Response to – SECTION 11 & ANNEX F – Landscape Character and Visual Assessment

SUBMISSION AGAINST JUPITER WIND FARM
Leonie Martin 63 Roseview Road Tarago NSW 2580

Figure 1 – View of my home at 63 Roseview Rd from West looking East to project site, definition has been given to the Meterological mast to clearly show its size on the landscape, at half the height of the proposed turbines.

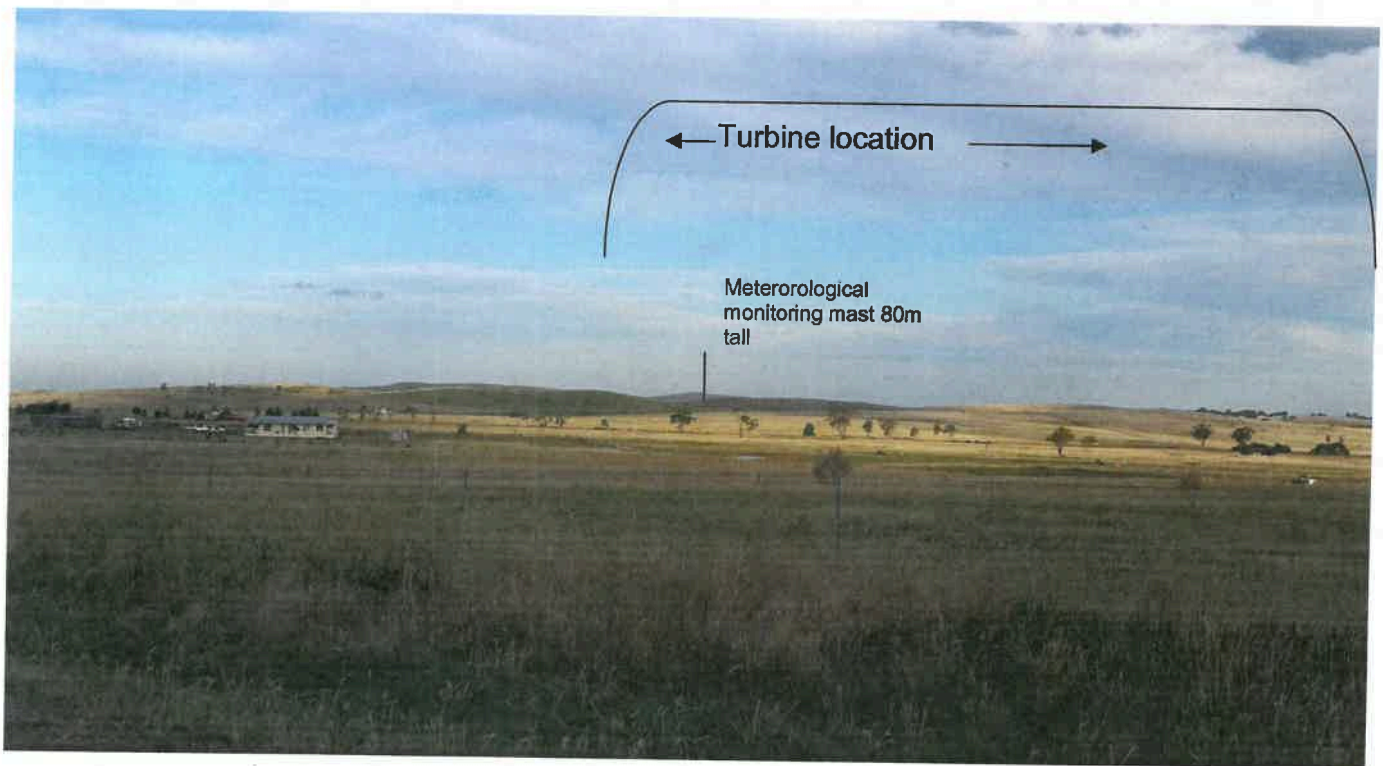
- 1) As per Figure 1 below – Actual view of my home on Roseview Rd from West showing east where Turbines will sit behind my home. This photo clearly shows the panoramic view and open grasslands of the area, proving that the visual impact of wind turbines in this area, can not be mitigated against. The EIS photomontage taken from Roseview Road fails to capture the full area of the proposed turbine location.

Figure 2 - Capital Wind Farm turbines 2000m from public road 'Taylors Creek Road'

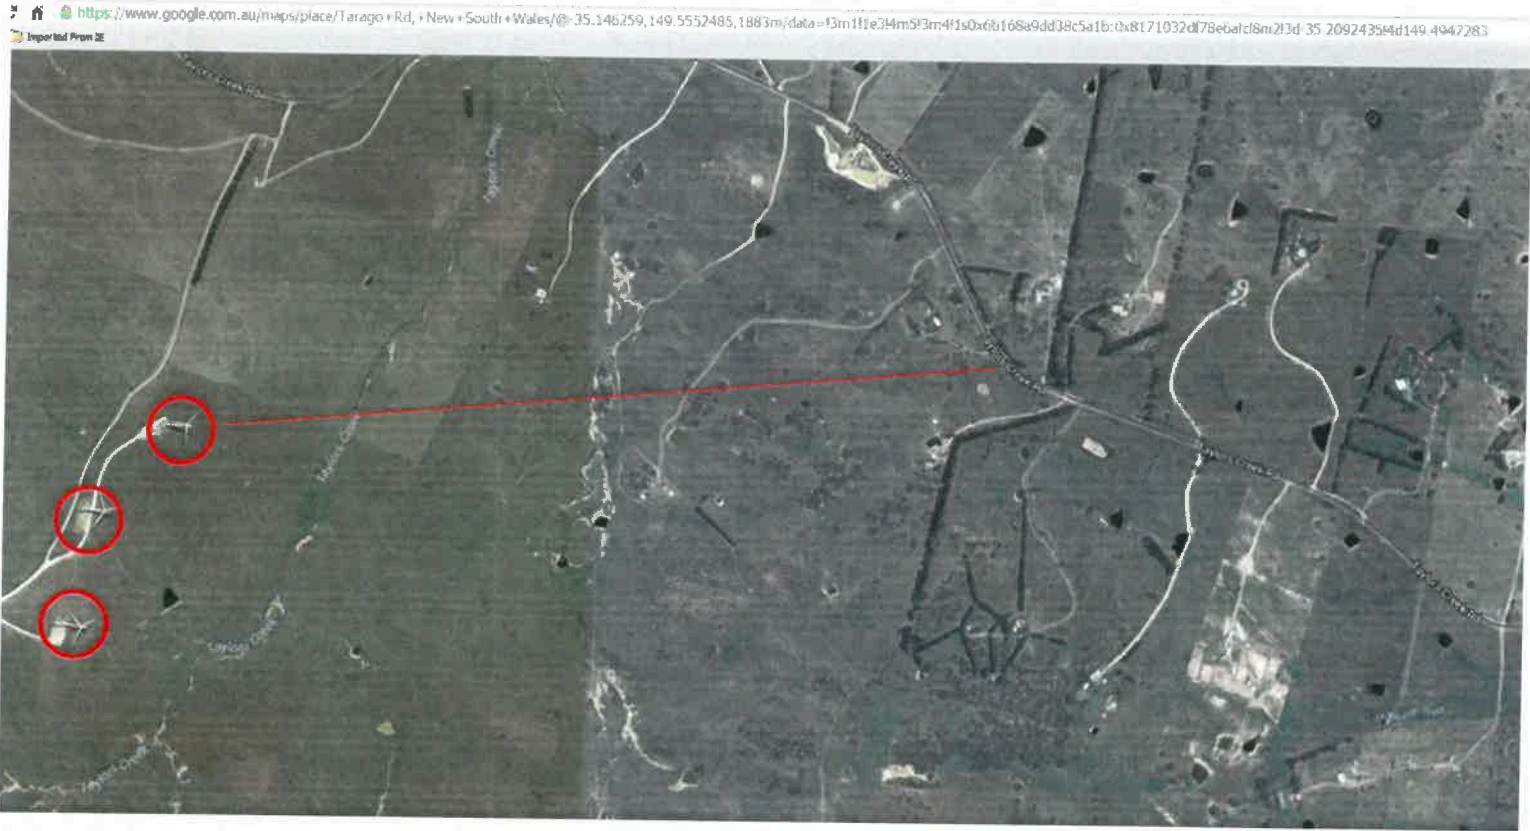
The following images show the Capital Wind Farm via satellite image and a photo taken from the ground of the wind turbines from 2000m away. I provide these images to show that the images provided with the Jupiter EIS are far from accurate. It needs to be noted that the Capital Turbines are 80m tall, compared to the proposed Jupiter Turbines of 173m tall.

Page 66 of Annex F 'Landscape and Visual Impact Assessment Report View Point 3 shows a photomontage of turbines at 1.3kms east of Braidwood Road, they are semi transparent and light grey and the figure of the turbines look not much taller than a small gumtree in the picture. Page 88 of this Annex, View point 11 from a driveway at Roseview Road shows the turbines as having a non-solid base, transparent even. As someone who is able to view first hand the turbines at Capital Wind Farm, the representation with the EIS of the turbines on the landscape are inaccurate.

You can see in the 'actual' photos from Capital Wind Farm, that the 80m tall towers, tower above the trees and the buildings located within 2kms of the turbines and are an obvious eyesore on the landscape. Now you are able to accurately imagine these at double the height to gauge a true impact that will be the Jupiter Turbines.
